**RE: PROPOSED RESIDENTIAL SUB-DIVISION
84-100 FRASER STREET, DARLING HEIGHTS QLD 4350
FURTHER ADVICE RESPONSE**

This letter is in response to the Council's Further Advice issued 8 July 2021 for the proposed Reconfiguring a Lot – Code – One (1) Lot into Five (5) Lots, located at 84-100 Fraser Street, Darling Heights. The traffic engineering issues being addressed are stated below in *italics*.

Client:
David Robertson C/- B Planned & Surveyed Pty Ltd
Title:
STOPPING SIGHT DISTANCE (SSD) ASSESSMENT &
SAFE INTERSECTION SIGHT DISTANCE (SISD) ASSESSMENT

Figure 1 – Hayden Street / Fraser Street intersection

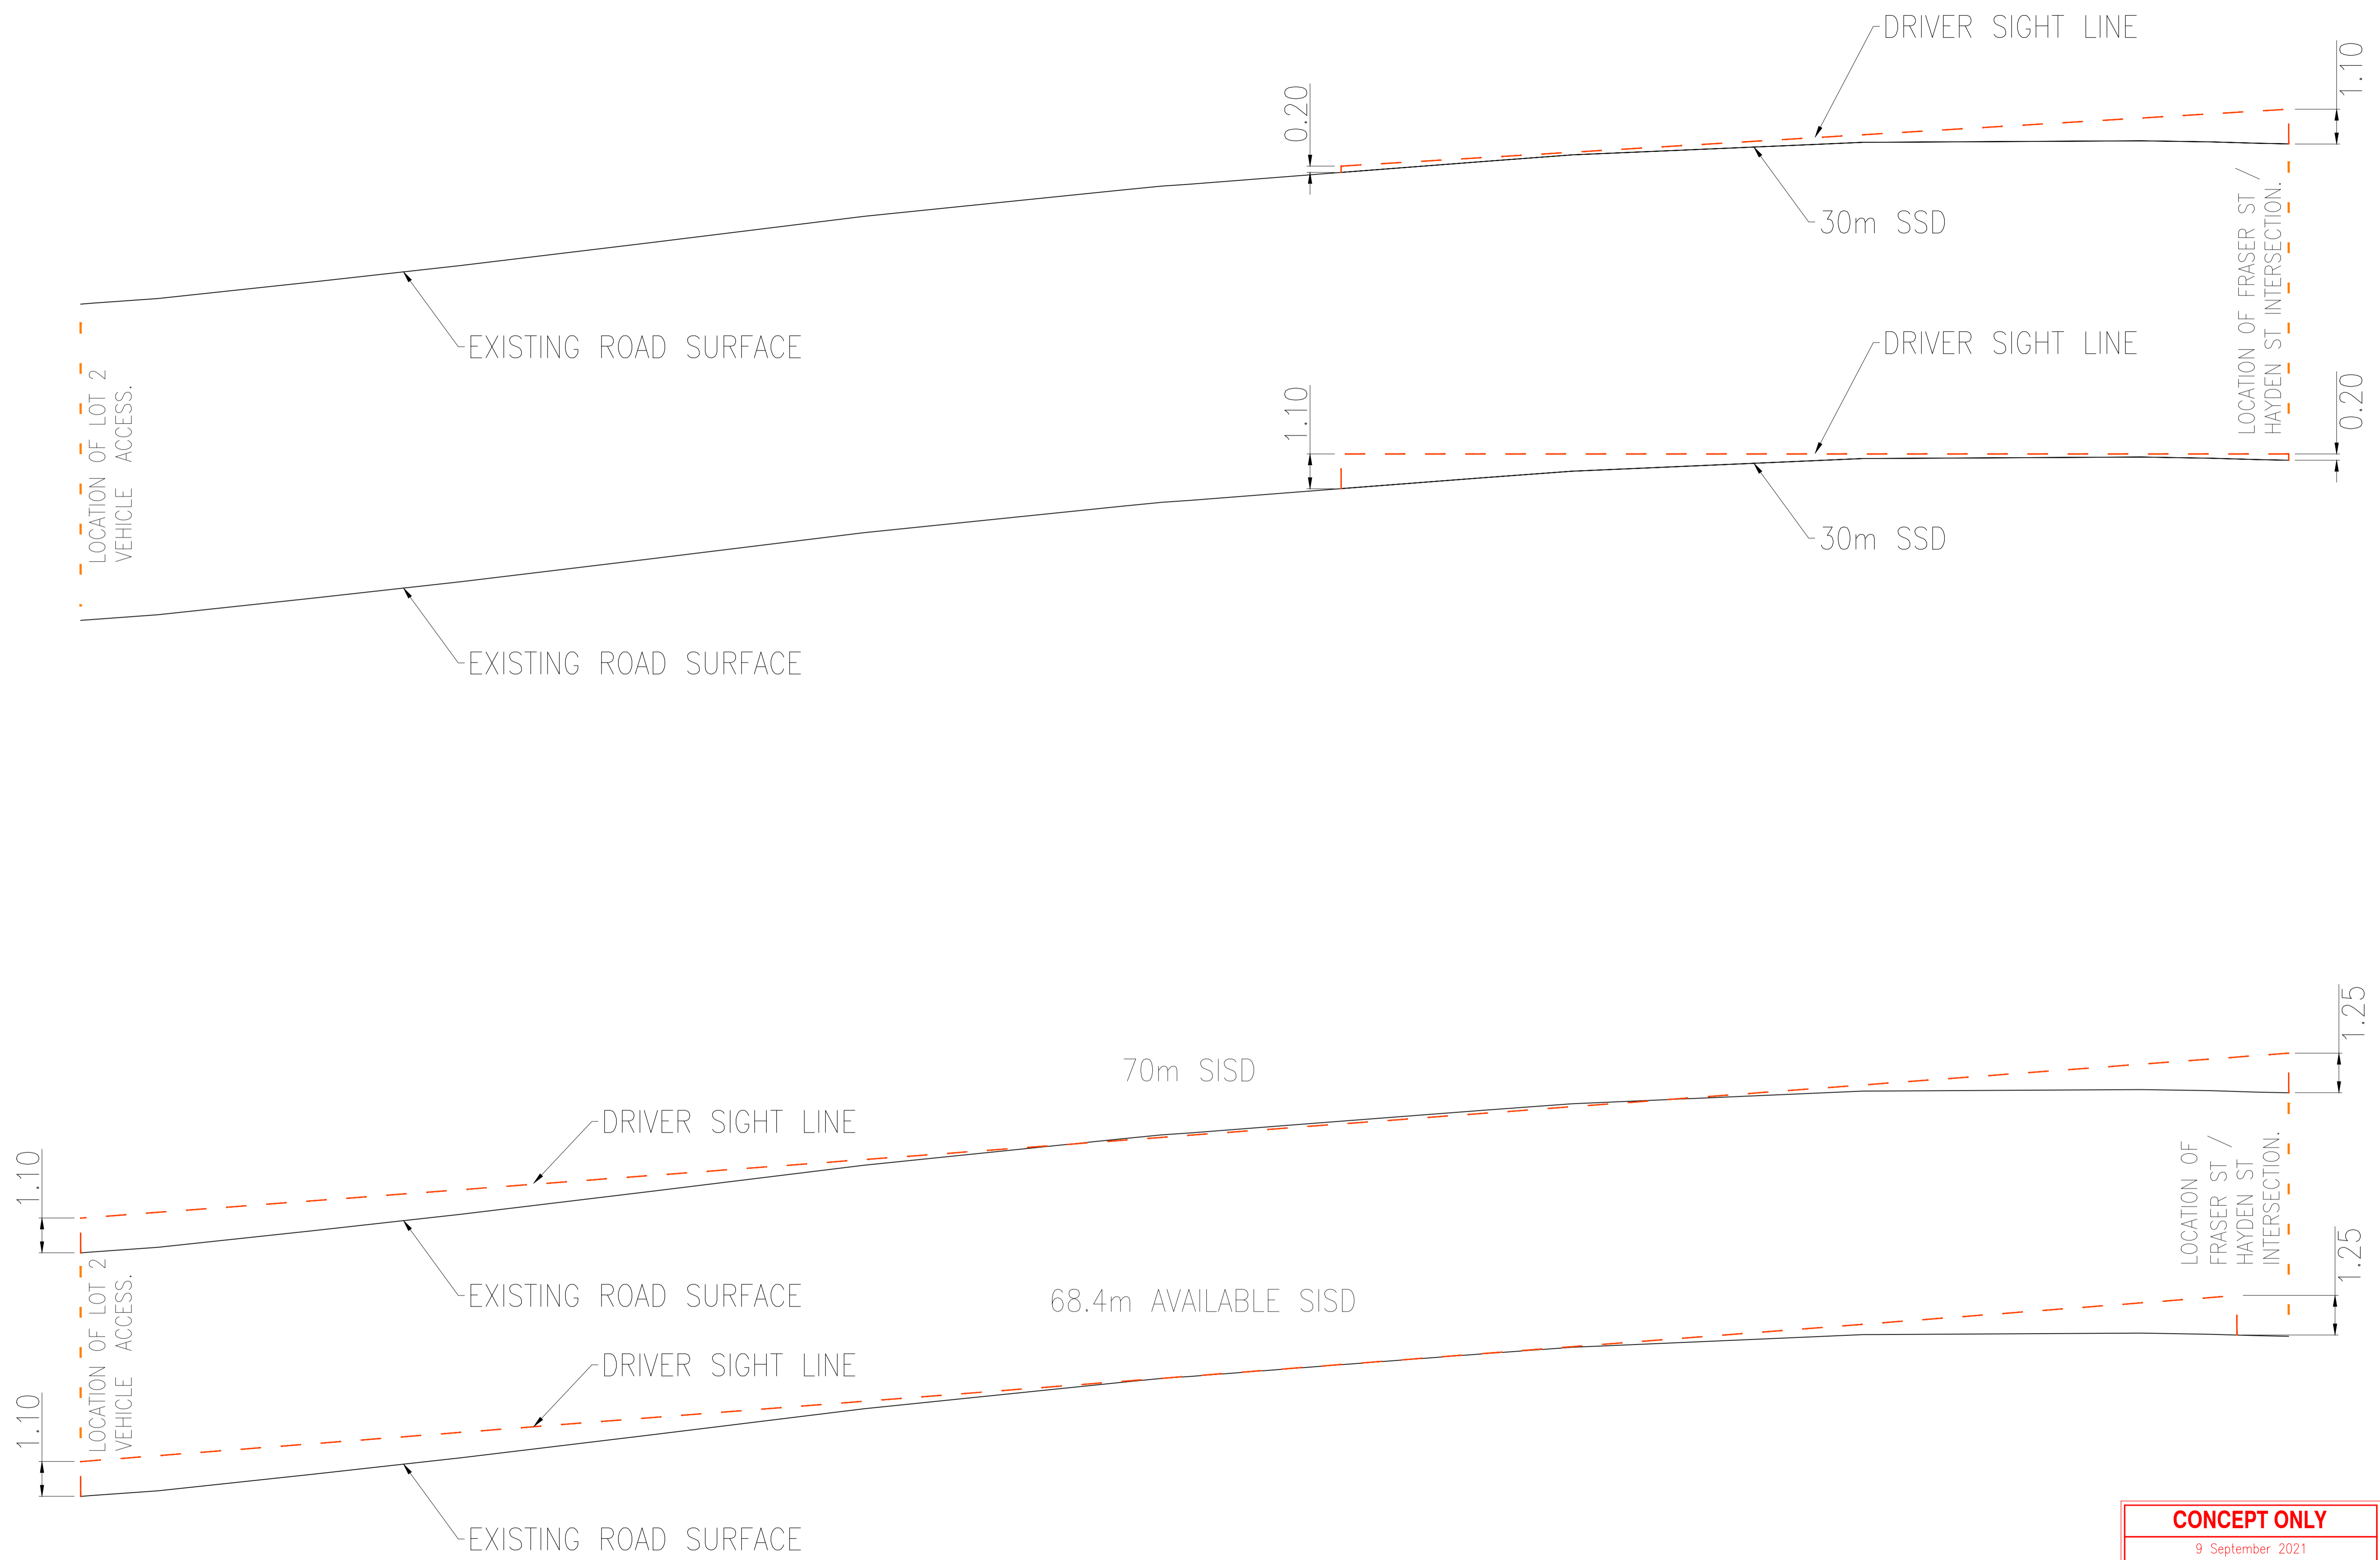
• *The TIA has not demonstrated that the proposed vehicular access to proposed Lot 2 will not have excessive adverse impacts on the surrounding road network. Specifically, it has not been demonstrated that sufficient Safe Intersection Sight Distance (SISD), Approach Sight Distance (ASD), and Minimum Gap Sight Distance (MGSD) is available when considering the overall topography, and the impact of the longitudinal grades of the road on braking distances; and*

- *The TIA has not considered the availability of Stopping Sight Distance (SSD) in the vicinity of the corner at the intersection of Fraser and Hayden Streets.*

A SISD assessment of Lot 2's access points was completed. This assessment found that due to the existing topography and longitudinal grades 67.3m of SISD to the south can be achieved from the proposed site access – see enclosed sight distance assessment.

We note though that the likely prevailing speed of a vehicle traveling around the corner will be much lower due to the existing sharp radii of the bend. We are of the view that the sight distance requirements needs to meet the frontage road speed relevant to the prevailing conditions. We note that This assumption is based on:

- that existing radii of the corner varies from R=~14m to R=~76m, as illustrated in **Figure 1**;
- assuming an average radii of 21m, superelevation of 3.5%max, and side friction of 0.03, the desirable speed the corner is calculated for 30km/hr; and
- the corner is currently signed at an advisory speed of 30km/hr in both direction, as illustrated in **Figure 1**; and
- it would not be possible for a vehicle to negotiate the bend at 70km/hr without a significant risk that they would run off the road

As Lot 2's access will provide adequate sight distance for a domestic property access on Fraser Street that has a frontage road speed of at least 60km/hr (minimum of 60m of sight distance, as per *AS2890.1 Figure 3.2 Note 6*), we are of the opinion that the proposed location of Lot 2's access is a suitable location for a single dwelling.

We also note that any sight distance requirements would need to meet speed relevant to the prevailing conditions of the corner 30km/hr which the design is likely to have been originally designed to – see enclosed sight distance assessment.
